Access Compliance Report

Public Rights-of-Way

Intersection ID: 26251	Main Street: BEVINGTON_PL	Cross Street: CHIPSTEAD_LN	Location: NE
ADA ID: 1FAB3C6C7F4E	Ramp Type: PerpDiag	Initial Pass/Fail: Fail	Overall Compliance: No
		Severity Score: 60

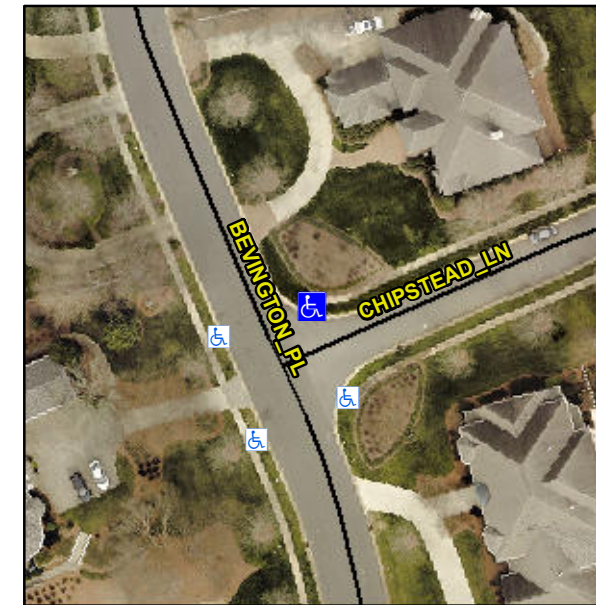
R304.5.1, R304.5.3

Compliance	Description	Data	Compliance	Description	Data
N/A	Ramp Length (in)	121.0	Yes	Ramp Slope (%)	5.2
No	Ramp Width (in)	25.0	No	Ramp XSlope (%)	8.5
N/A	Flare Type LT	N/A	N/A	Flare Type RT	N/A
N/A	Flare Slope LT (%)	N/A	N/A	Flare Slope RT (%)	N/A
N/A	Flare Traversable LT?	N/A	N/A	Flare Traversable RT?	N/A
N/A	Landing Length (in)	N/A	N/A	DWS Provided?	N/A
N/A	Landing Width (in)	N/A	N/A	DWS Contrast?	N/A
N/A	Landing Slope (%)	N/A	N/A	DWS Length (in)	N/A
N/A	Landing X Slope (%)	N/A	N/A	DWS Full Width?	N/A
N/A	Landing Curb? (Y/N)	N/A	N/A	DWS Offset (in)	N/A
N/A	Shared Landing?	N/A			
N/A	Gutter Ponding?	N/A	N/A	Gutter Slope (%)	N/A
N/A	Gutter Lip Ht (in)	N/A	N/A	Gutter X Slope (%)	N/A
N/A	Painted X Walk1?	No	N/A	Painted X Walk2?	No
	X Walk 1 Direction	To W		X Walk 2 Direction	To SE
N/A	X Walk 1 Width (in)	N/A	N/A	X Walk 2 Width (in)	N/A
	X Walk 1 Slope (%)	2.9		X Walk 2 Slope (%)	1.5
	X Walk 1 X Slope (%)	3.2		X Walk 2 X Slope (%)	2.7

Remove & Replace Curb Ramp With Two New Directional Ramps or Equivalent.
